## Determination 2009/77

### Determination regarding the refusal to issue a code compliance certificate for a 6-year-old block of 4 semi-detached townhouses at 3 to 9 Kora Avenue, Waitakere City

3.1 The following site plan shows Block B:

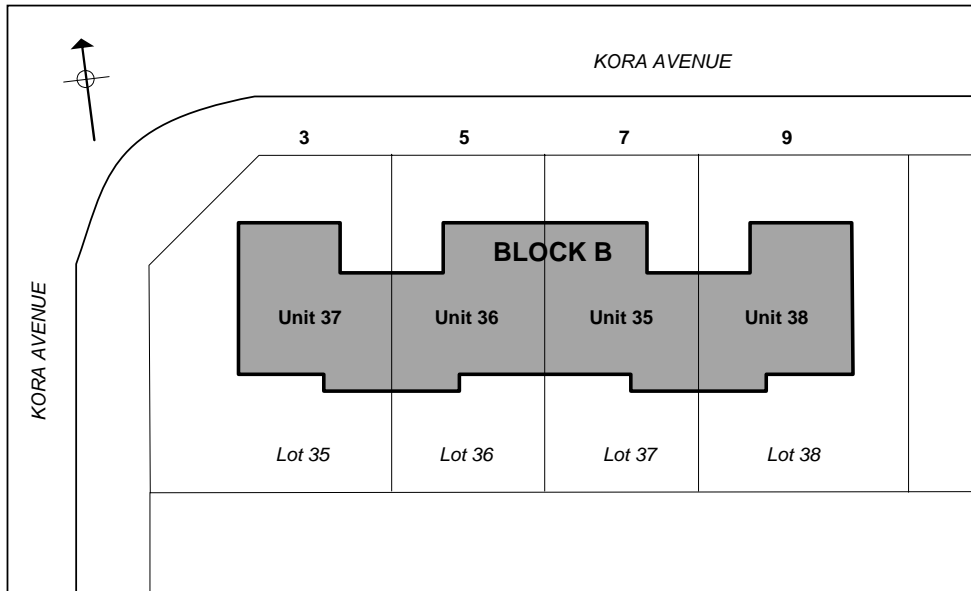
3.2 Block B is a 2-storey building, which is situated on a flat site in a low wind zone in terms of NZS 3604<sup>3</sup>. The block sits on the corner of Korā Avenue, with the main entries and garage doors facing north towards the road. The building is fairly simple in plan and form, with garages set back from the front wall. The ground floor
